WHITE PAPER NO. 5A – RESPONSES TO THE API PANEL REPORT

Response to a Document by The Johnson Company

**ECOSYSTEM-BASED REHABILITATION PLAN –
AN INTEGRATED PLAN FOR HABITAT ENHANCEMENT AND
EXPEDITED EXPOSURE REDUCTION IN THE
LOWER FOX RIVER AND GREEN BAY**

This Document has been Prepared by
Wisconsin Department of Natural Resources

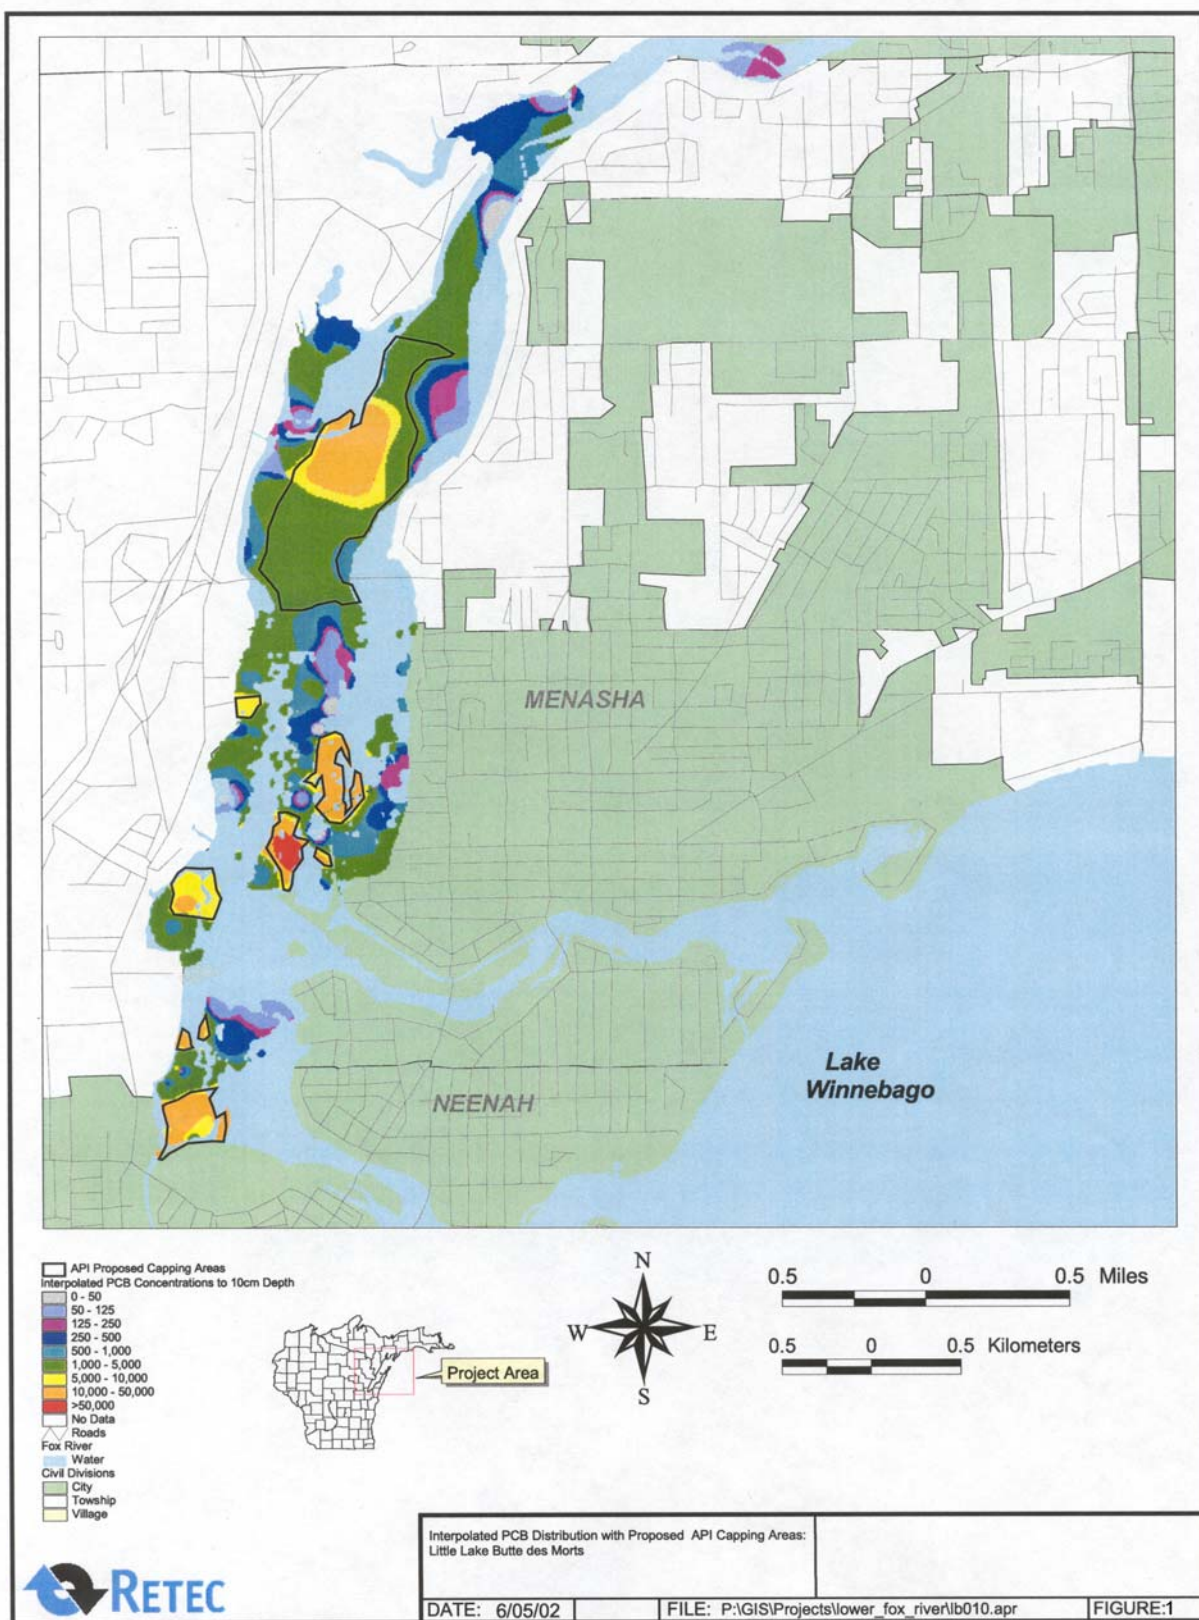
Figures 1 through 3 show the capping locations proposed by the API Panel for each of the three Operable Units. For OU 1, the capping areas correspond to those areas where PCB concentrations were greater than 5 ppm, with the exception that the API Panel did propose capping a larger section of Deposit E that included some portions where concentrations exceeded 1 ppm. Operable Unit 3 (Figure 2) follows a similar pattern, with portions of Deposit EE also included in the capping action. In OU 4, substantive portions of the entire reach are proposed for capping, including portions within the federal navigation channel. As noted above, the digitized areas corresponded within a few percentage points of the areas listed in the Panel Report.
